ZA921: Little Court, Wratting Road, Haverhill
Transport Technical Note 02: Transport Matters
For CARE (Little Court)
Aug 2021

Application Reference: DC/21/0315/FUL

1.3 This Technical Note (02) has been prepared to respond to the remaining comments made by SCC.

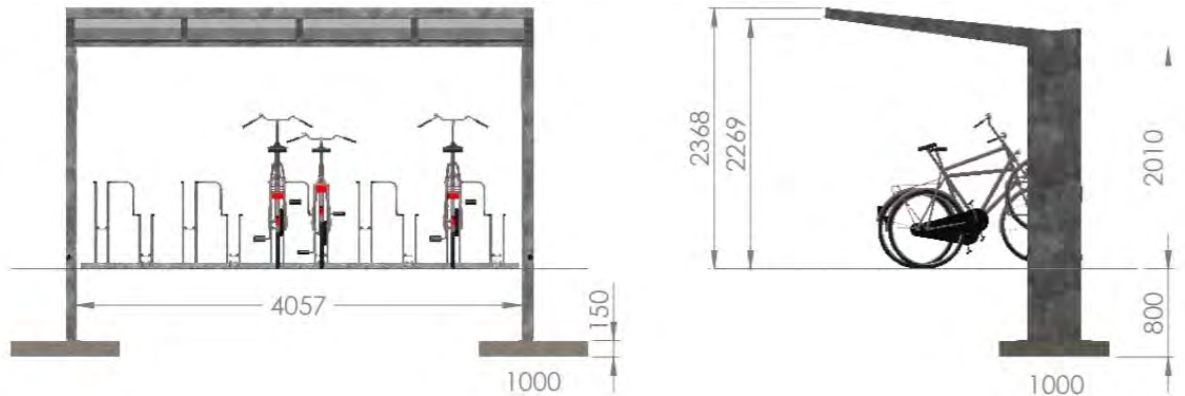
SCC Comment 1: We recommend the applicant provide an off-road footway and cycleway linking the site to Haverhill via the infrastructure already available or to be provided by the Great Wisley development as part of currently approved highway improvement works. We cannot accept any sustainable links based on an assumption of infrastructure not yet delivered, regardless of planning consents, in case they do not come forward.

A footway connection is proposed from the existing footway on the northern side of AA143 to the site. An uncontrolled crossing is proposed to allow pedestrians to cross to gain access to the site.

DRAWING NUMBER ZA921-PL-DR-001	REV. P09
-----------------------------------	-------------

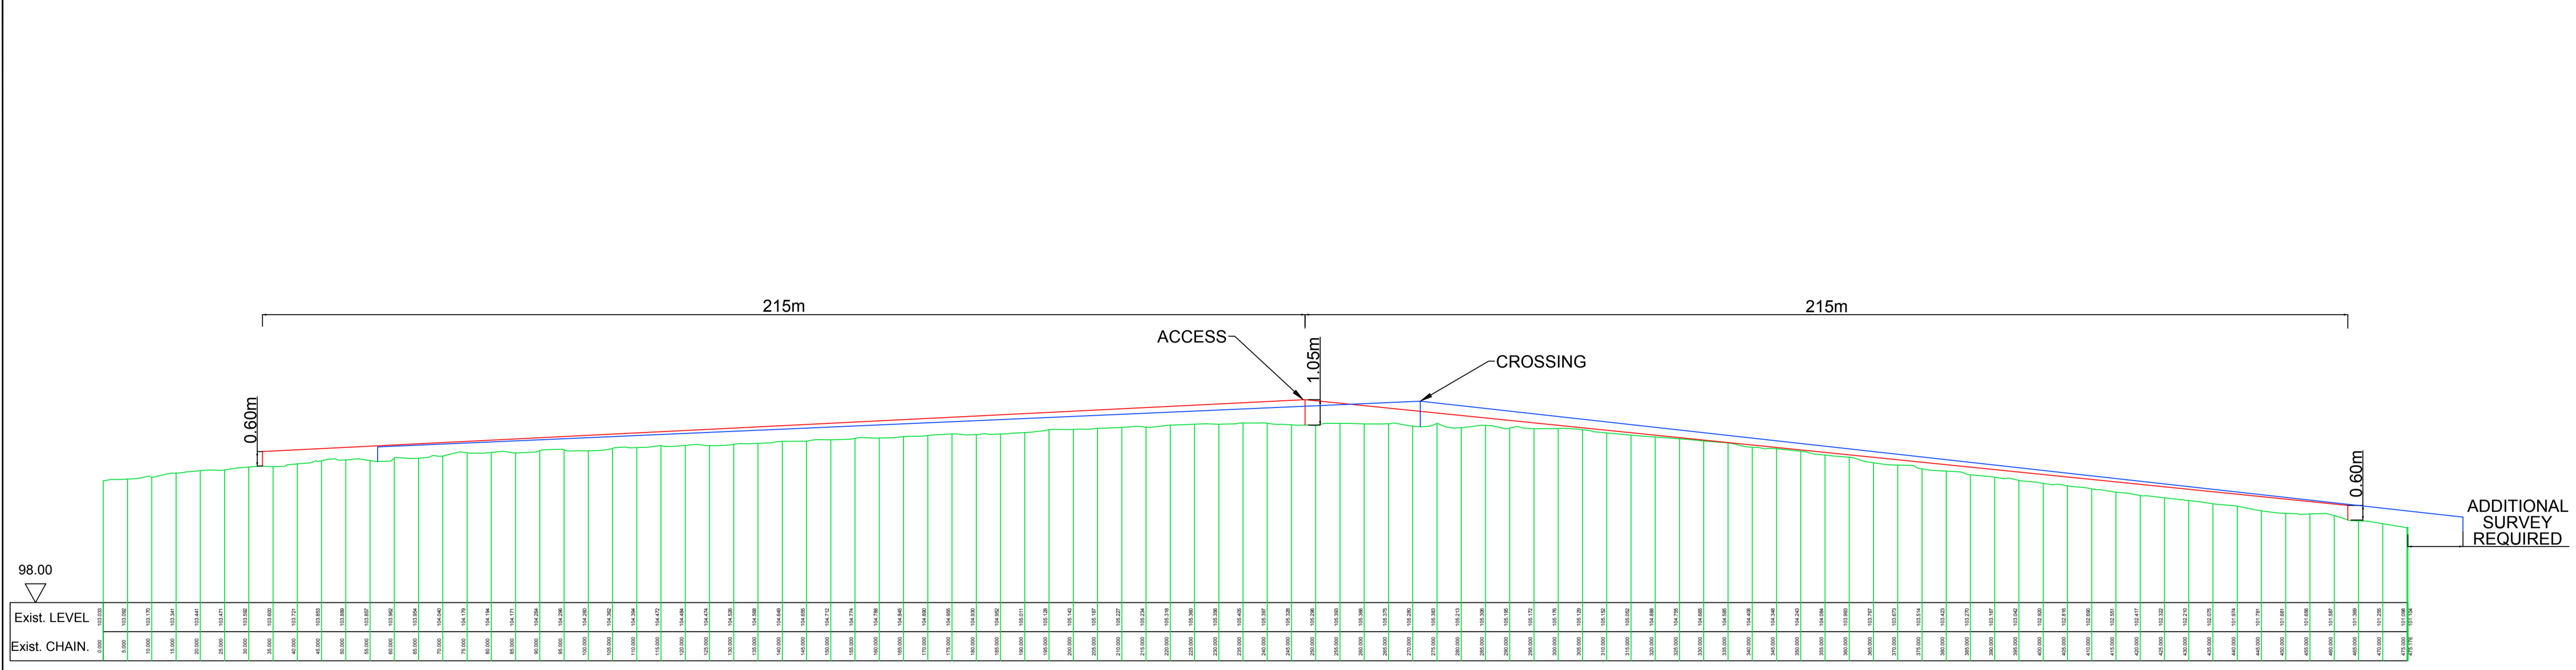
SCC Comment 3: An existing access to the west of the proposed access is stated as 'to be retained'. As shown this is unacceptable because it is not designed to join the new access at a suitable angle, is not sufficiently wide for 2 vehicles to pass and the path of exiting vehicles will cross the proposed pedestrian crossing point.

SCC comment 4: The design of the cycleway way shows pedestrians and cyclists (dismounted) must cross the proposed access, then immediately cross the existing access.

SCC Comment 7: The applicant suggests the use of flexible verge markers to prevent parking up on the verges near the site. This could work to prevent on street parking.

In response to the RSA, CCE have therefore updated the access strategy to maintain cyclists on the carriageway (**Drawing ZA921-PL-SK-001-P09**). Eastbound cyclists have been provided with a place to leave the carriageway and cross safely to reach Little Court.

CCE Comment 3: This is a driveway to a single property only. The property will predominately use their other drive which is the next junction to the west of the proposed site access. The existing drive has been retained in its current arrangement.

The point at which it meets the site access road has been adjusted to prevent overrun.

CCE Comment 4: Pedestrians and cyclists will cross the existing driveway however traffic movements associated with this will be very low (single dwelling only and the property will predominately use their other access).

CCE Comment 5: A RSA has been undertaken by Road Safety Consulting. This RSA and Designers Response is included in **Appendix B. Drawing ZA921-PL-SK-001-P06** is now superseded by **Drawing ZA921-PL-SK-001-P09** which reflects the comments made by the RSA.

CCE Comment 7: Flexible verge markers have been included in on **Drawing ZA921-PL-SK-001-P09**.
